To: Plan Holders for Improvements to the  
Kirksville Regional Airport  
Kirksville, Missouri  
MoDOT Project No. 20-0298A-1

**ADDENDUM NO. 2  
 TO  
 CONTRACT DOCUMENTS, SPECIFICATIONS AND PLANS  
 FOR IMPROVEMENTS TO THE  
 KIRKSVILLE REGIONAL AIRPORT  
 KIRKSVILLE, MISSOURI  
 MODOT PROJECT NO. 20-028A-1**

**RUNWAY 18/36 AND  
TAXIWAY B  
REHABILITATION**

**ELECTRICAL DETAILS**

**SHEET NAME**  
E251  
**SHEET NO.**  
61 of 62

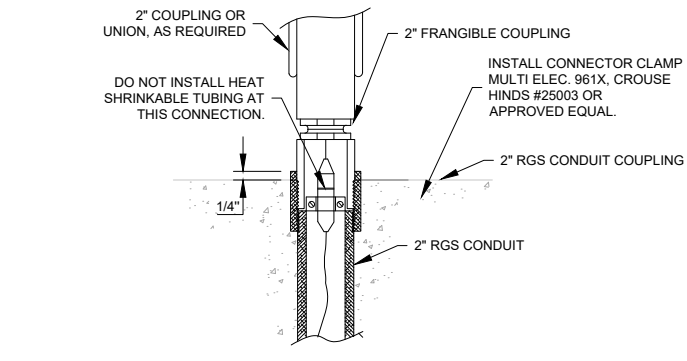
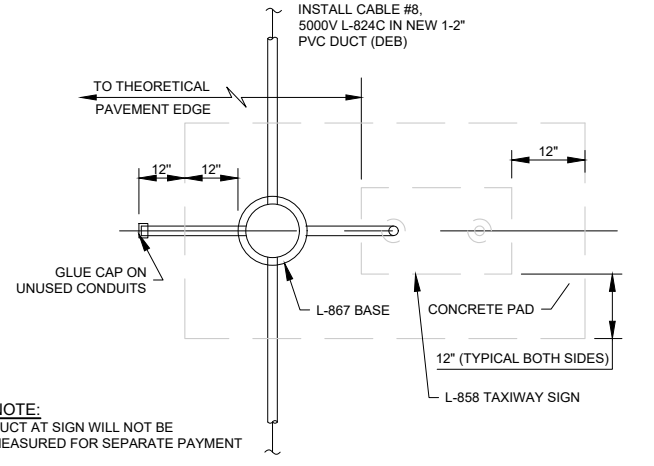
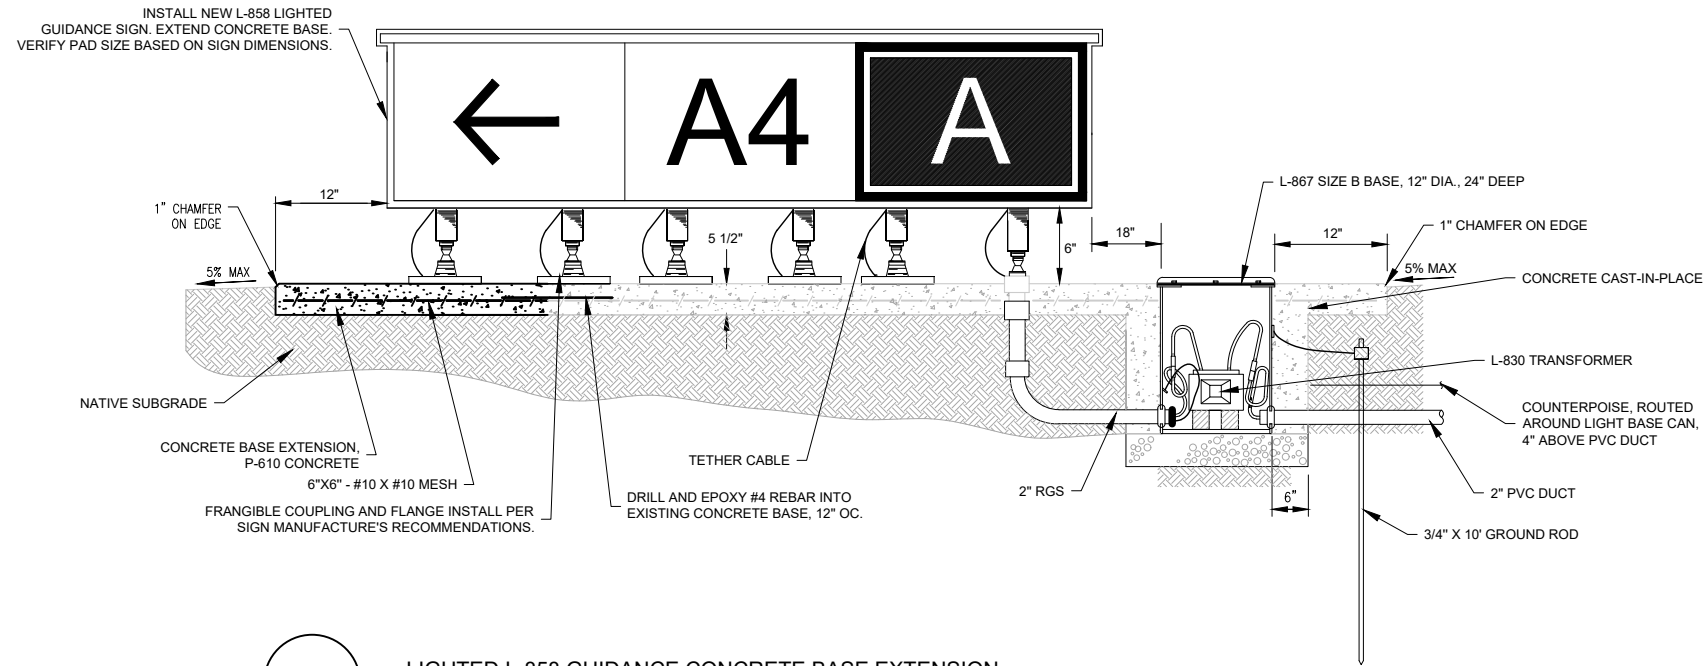
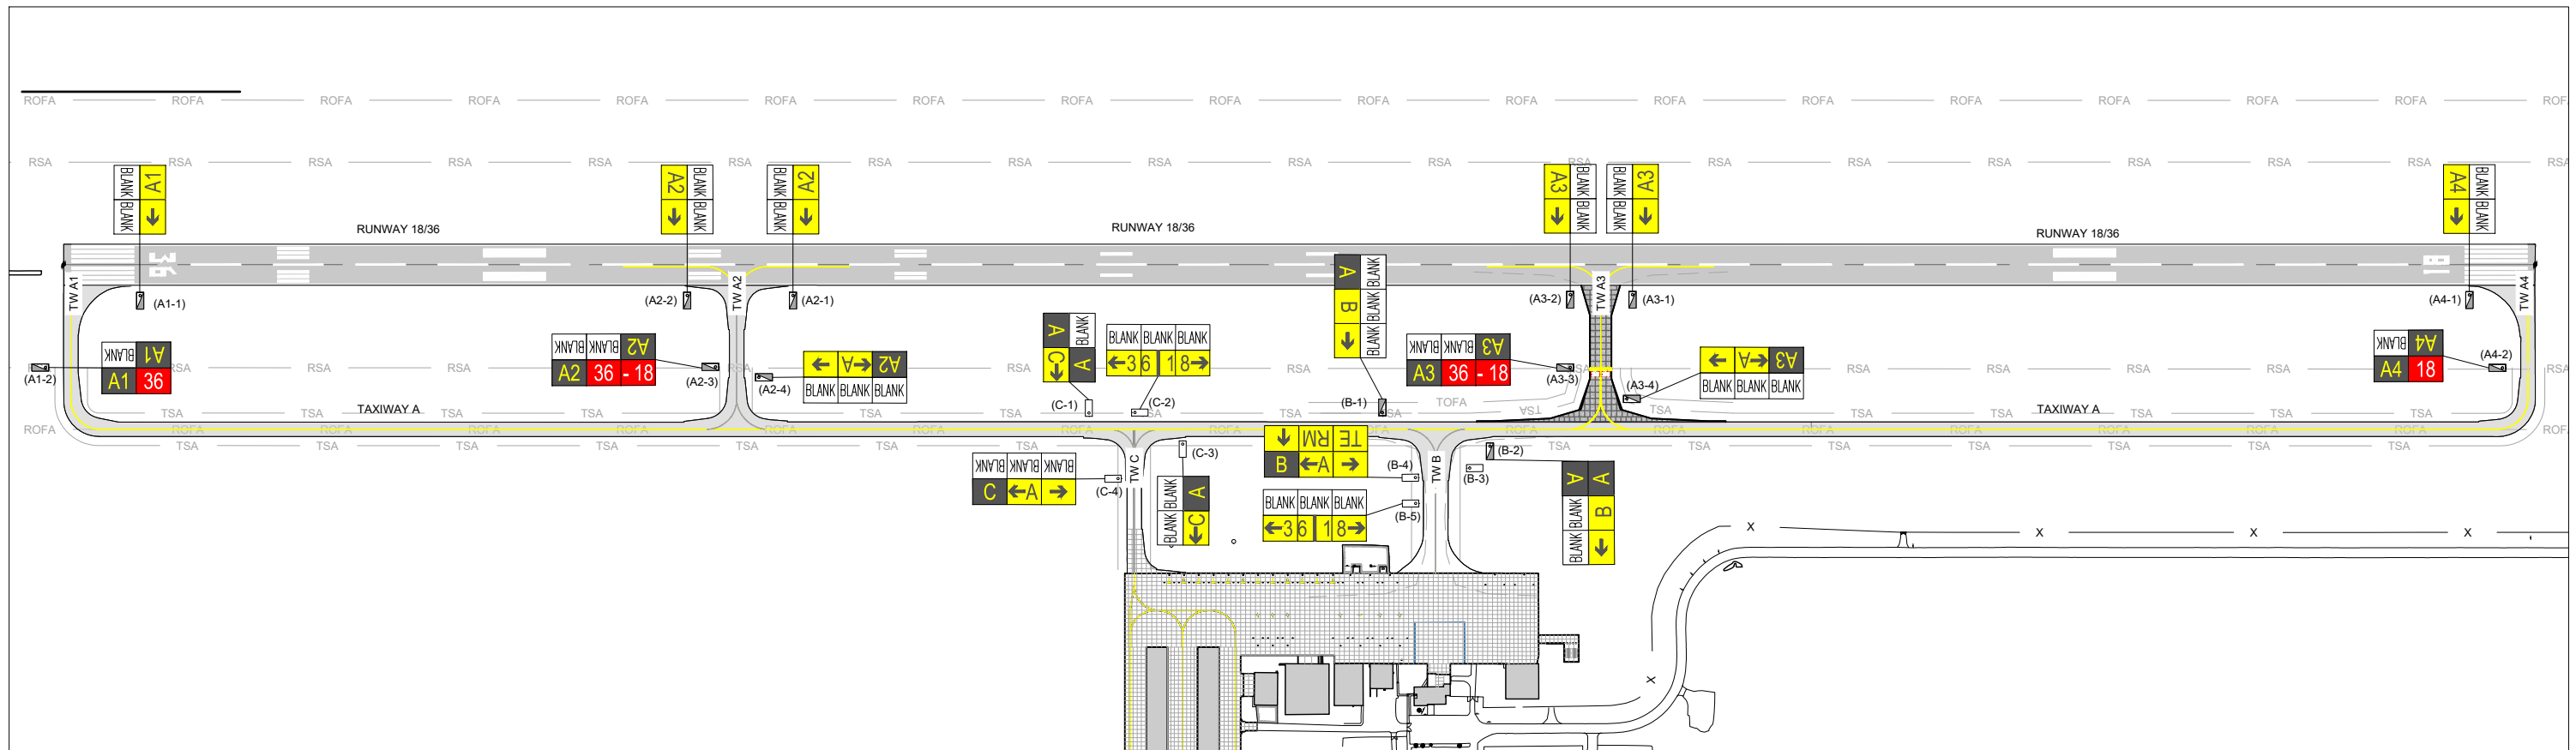
**E251 (61 of 62)** – The sign details were updated to reflect the different installation types. The sheet has been reissued and is attached with this addendum.

*Justification: The existing signs are old and will not be able to be extended. New signs will be installed instead.*
